BendPak Technical Service Bulletin 10AP-168 and 10APX-181 Hydraulic Hose Change

BendPak TSB 139-072024 Rev. A1

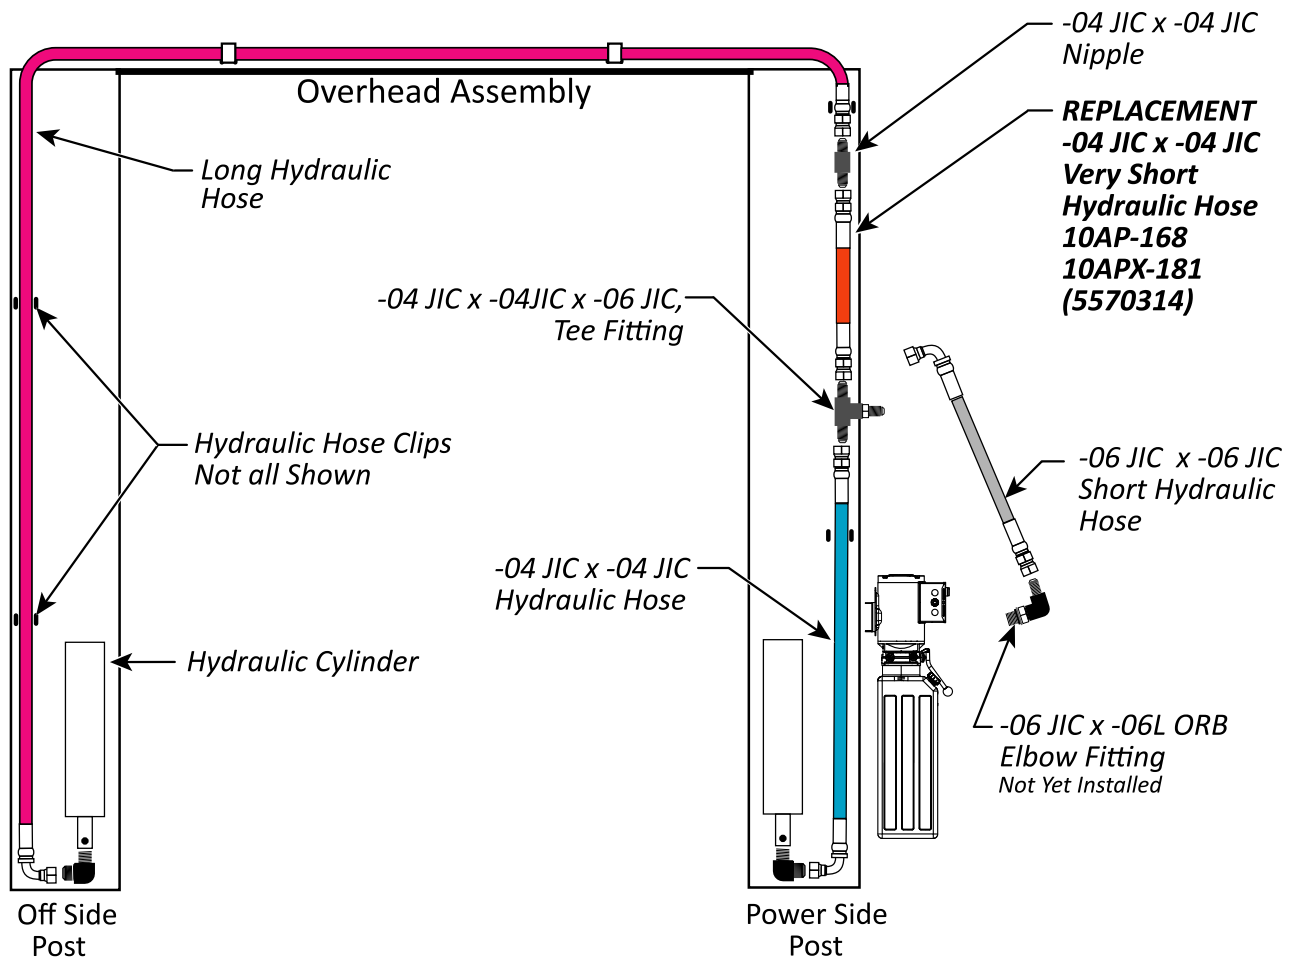
On all 10AP-168 and 10APX-181 Two-Post Lifts, the very short hydraulic hose $\text{Ø}6.35 \text{ mm} \times 285 \text{ mm}$ (5570174) will be replaced as depicted below. The new Hose Assembly (5570314) removes the elbow JIC fitting and replaces it with a straight JIC fitting.

The revised Hose Routing Diagram on the next page details the hose position and fittings required.
